BIDDING AND CONTRACT REQUIREMENTS
ADDENDUM NUMBER 2

Architect's Project Number:
224151.00

Re: **Addendum Number 2 to the bidding documents for:
Moline – Coal Valley School District #40
Browning Field Concessions and Toilet Room Improvements**

1 ROOF FRAMING PLAN
1/8" = 1'-0"

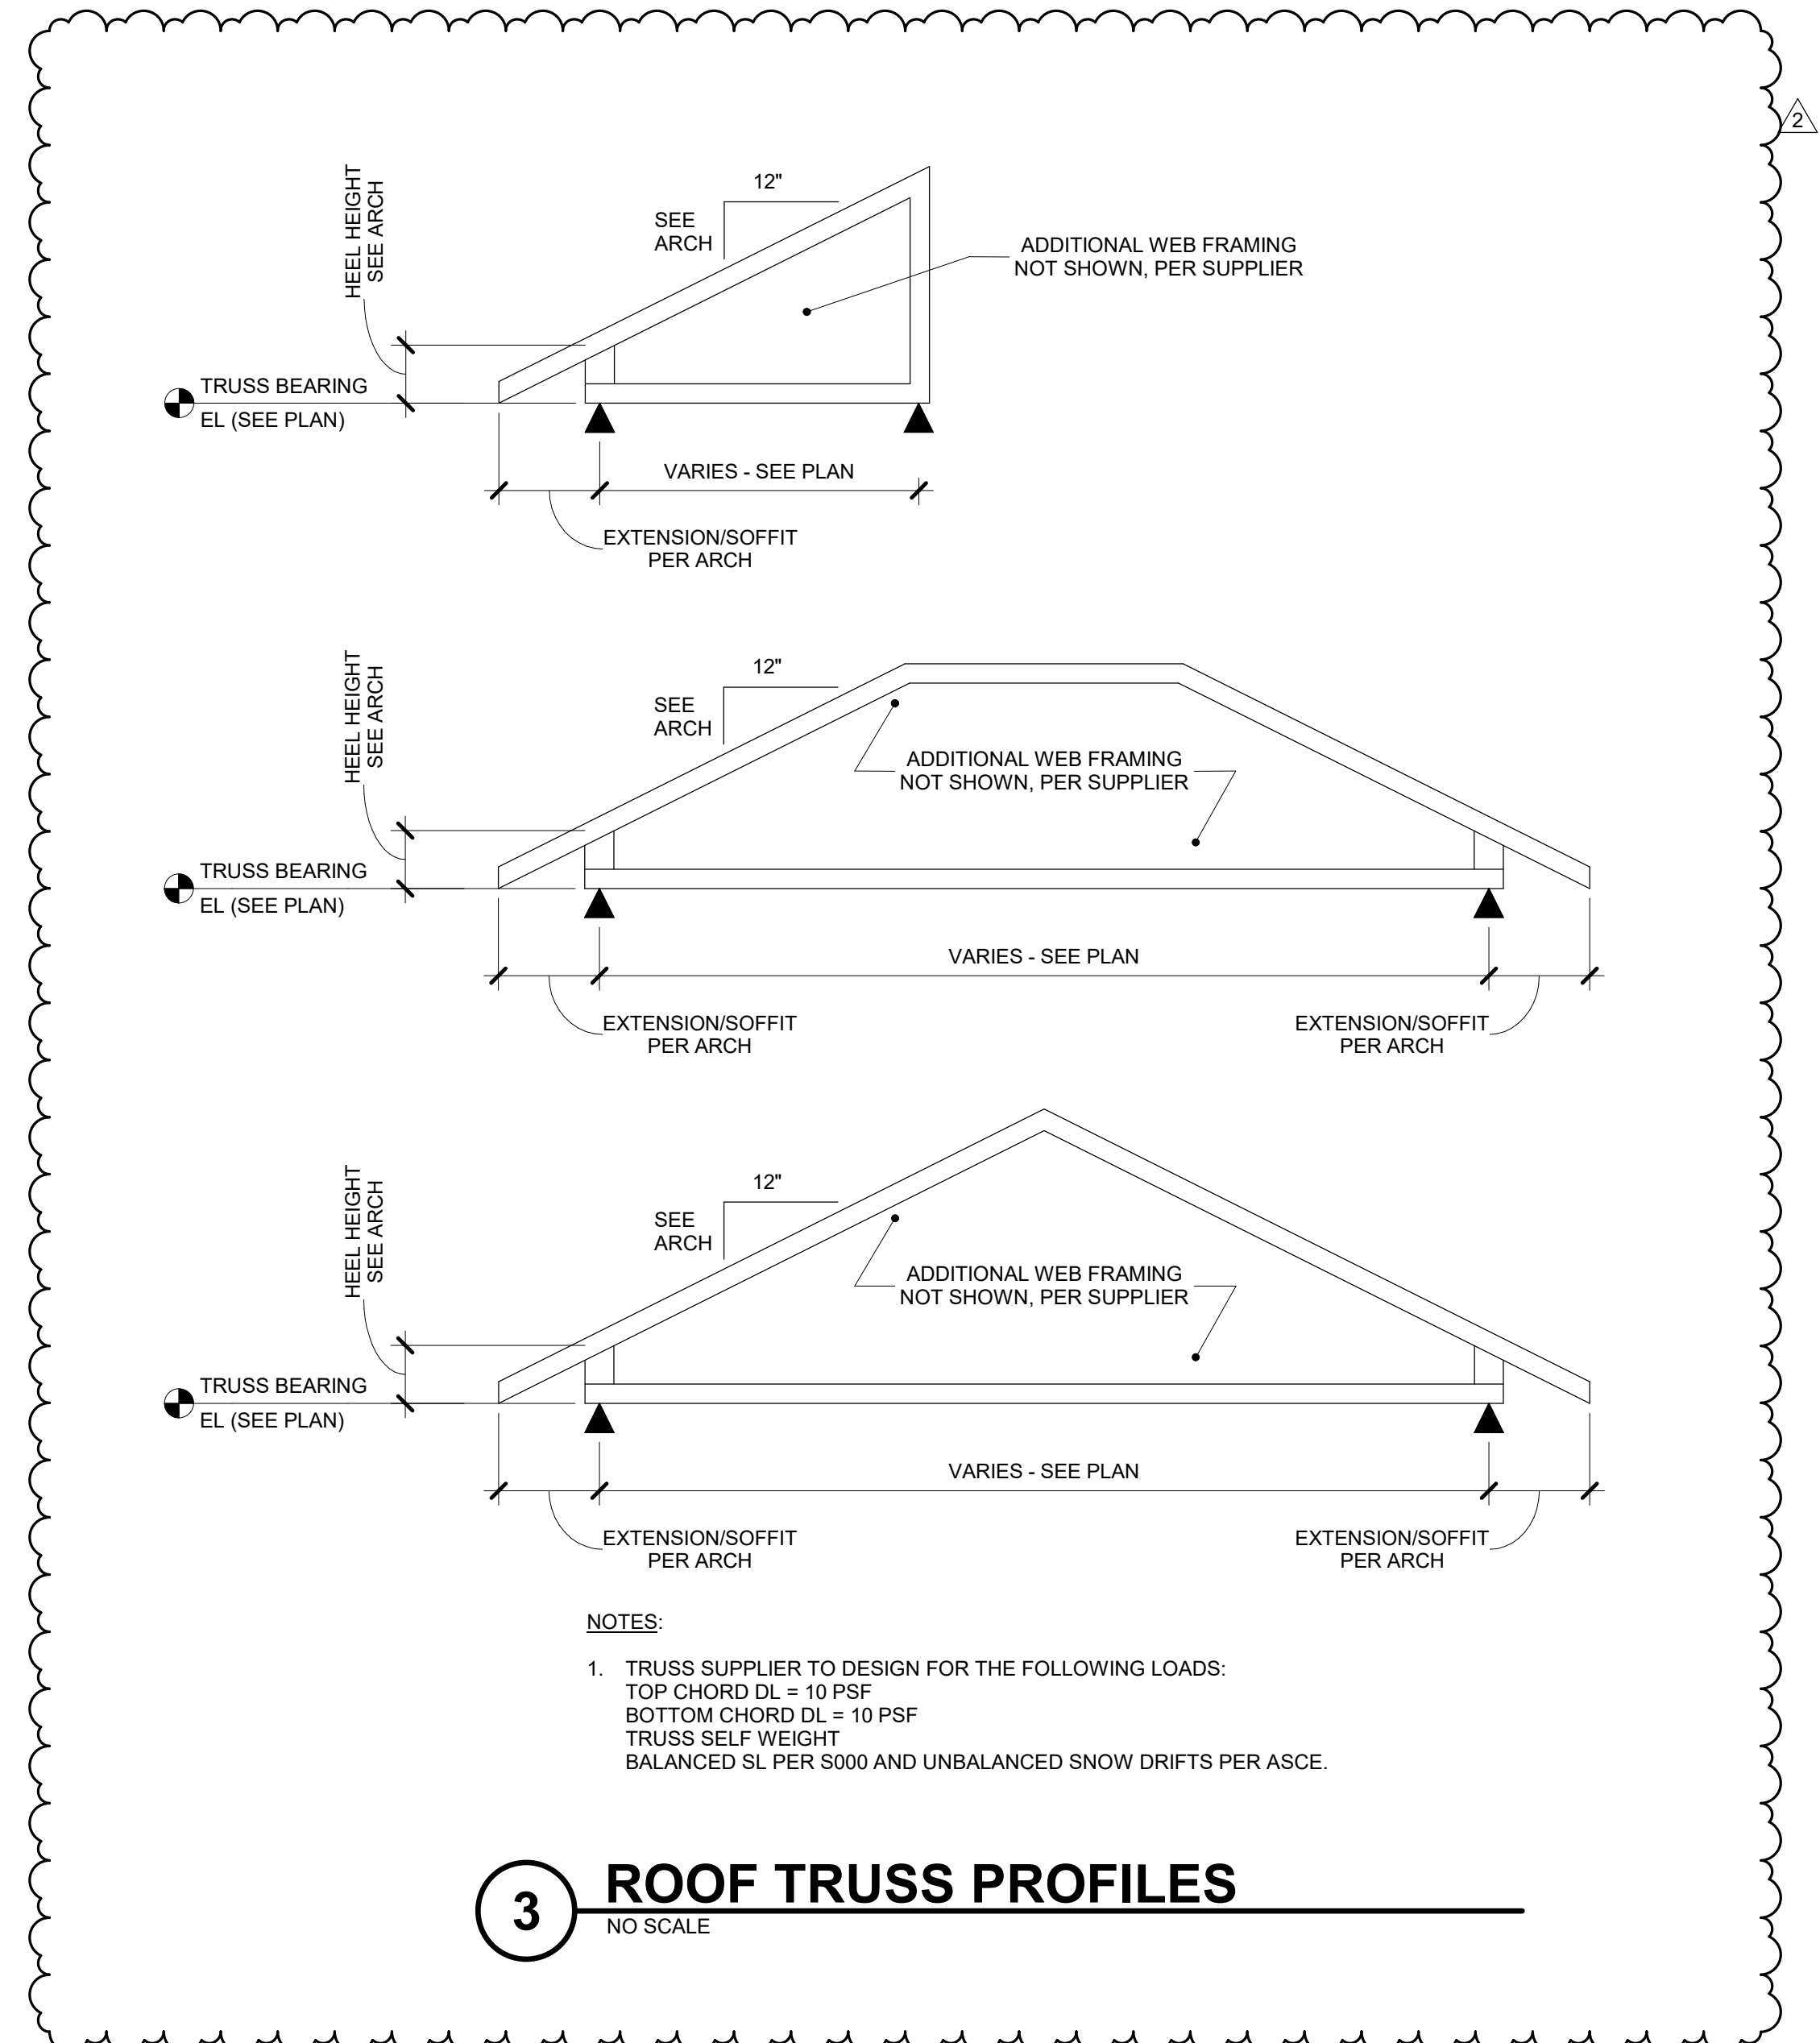
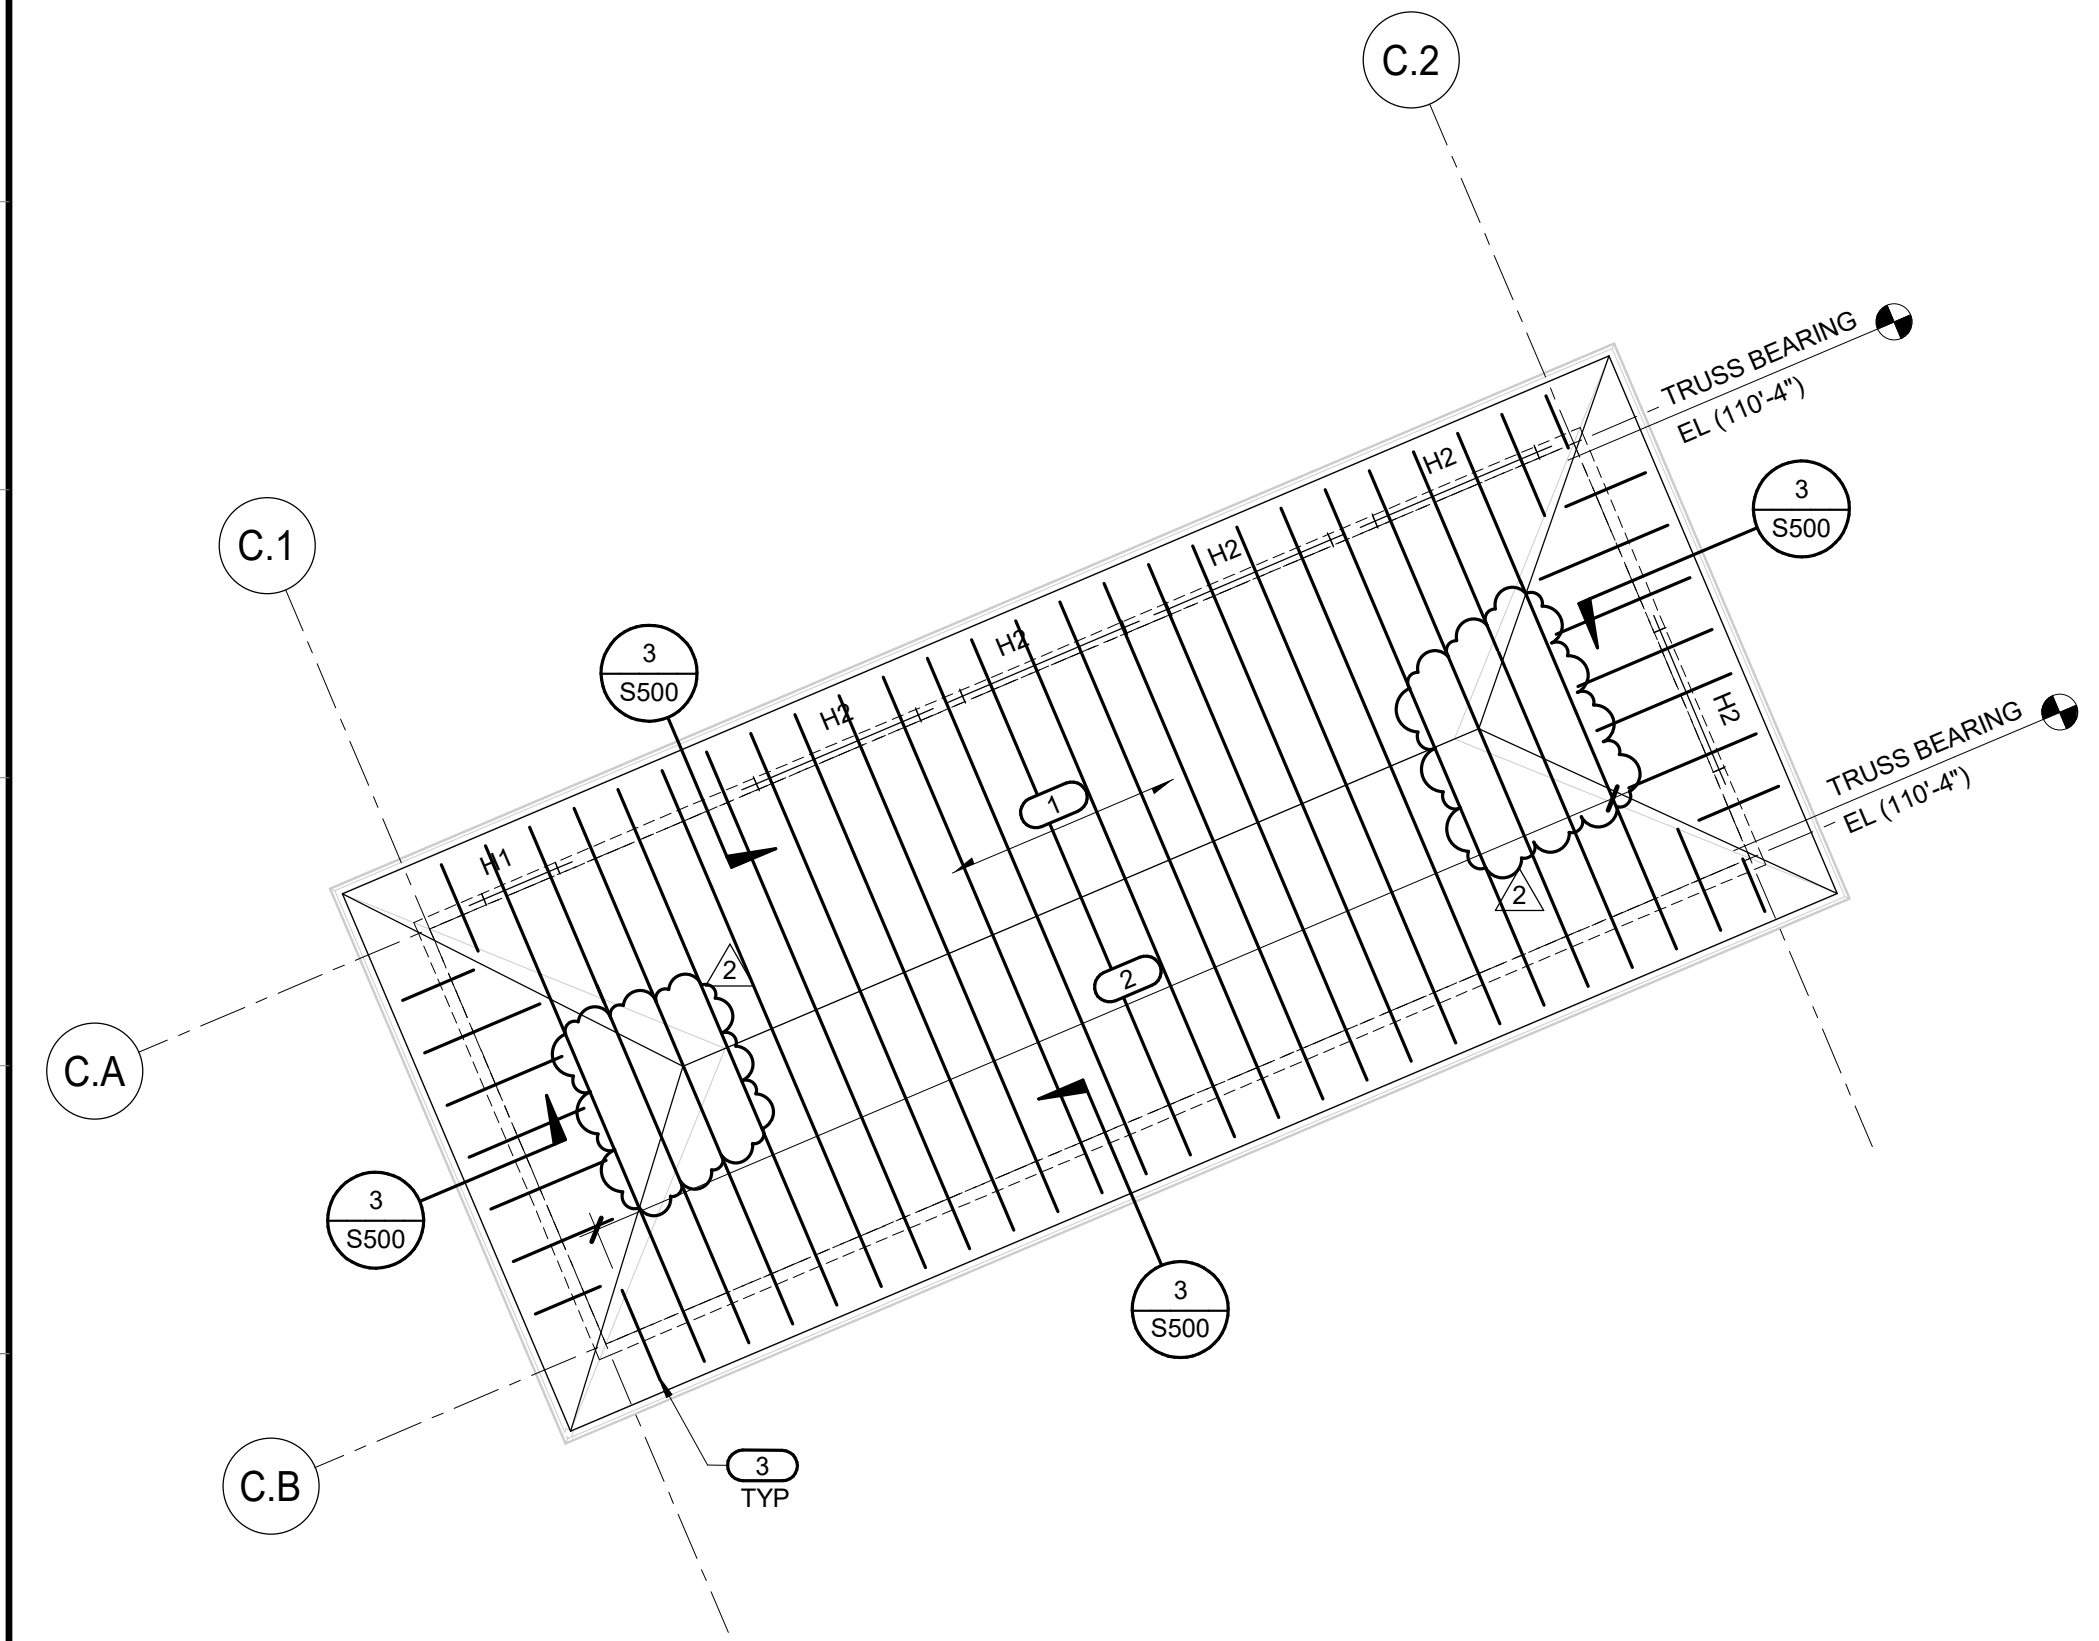
E. Drawing S101, titled, **ROOF FRAMING PLANS.**

1. **REVISE** roof truss profiles.
2. **REVISE** sheet notes.
3. **ADD** Keynote 3.
4. **REVISE** truss framing.
